WRITTEN PUBLIC COMMENT

Docket Number: 1609-PUD-14 (Ord. 16-29)
Petitioner: Matthew and Teresa Skelton
Request: A change in zoning from the SF3: Single-Family Medium Density District to the Junction North Planned Unit Development (PUD) District.

JUNCTION NORTH PUD 1609-PUD-14, Ordinance No. 16-26 or 29

Comments: 161st Street Neighbors, Linda Naas

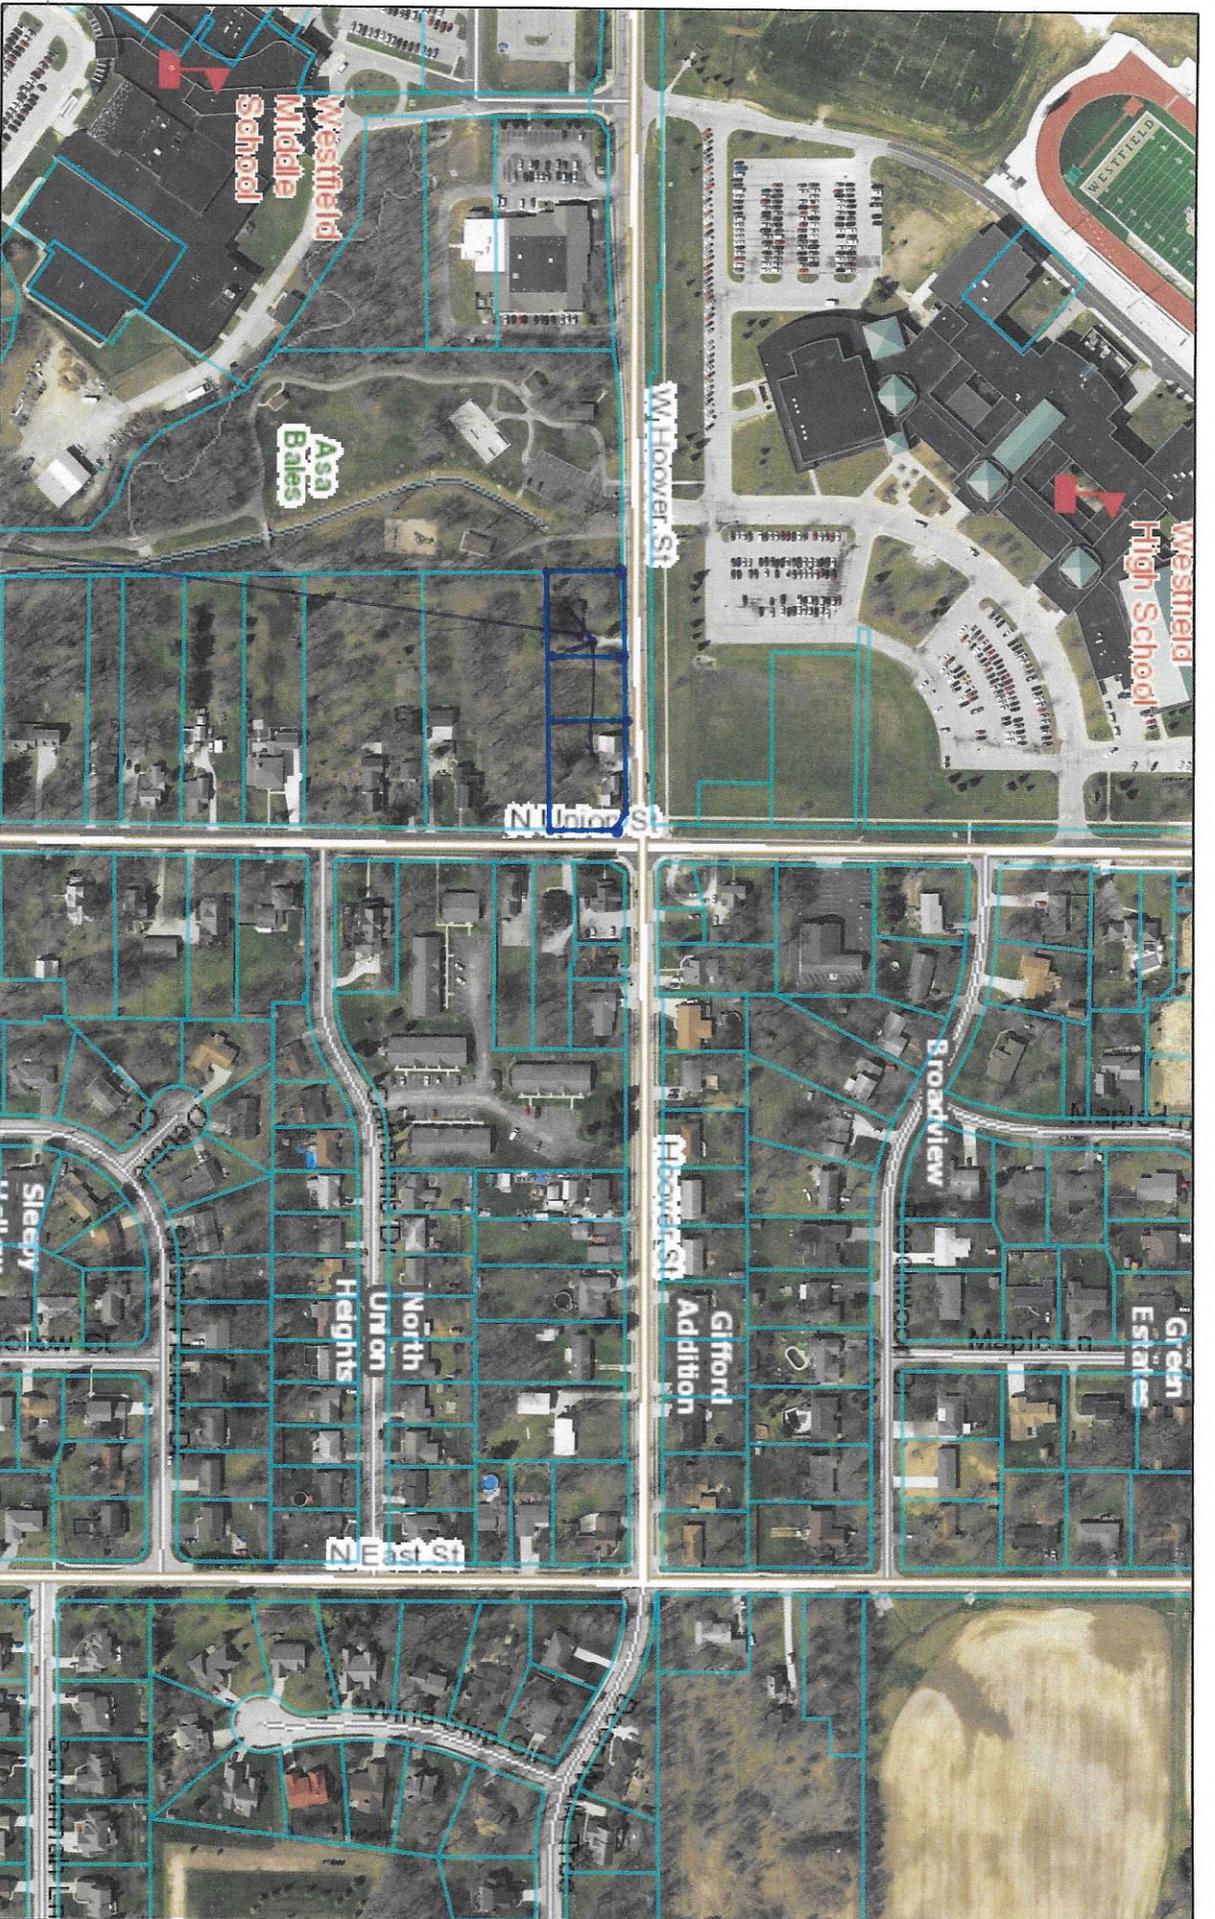
Path/Sidewalk. Why 5' not 8' path since this carries traffic to Asa Bales Park, school properties, Library, along 181st to Grand Park or Grand Junction? Recently Skelton's office pushed for an 8' path from the Hebrew Cemetery when they only wanted to give a 5'. There should be 8'

paths/sidewalks on east and north side of PUD. On the west side of these parcels is an 8' pathway through Asa Bales Park.

ROW should be given as any other development has to give it. 181st Street/Hoover St is becoming a more travelled route from GJ to GP and will need to expand.

No open space. Why not in a PUD?

What kind of transition/barrier between PUD and the park/library to the west? Nothing in the PUD.
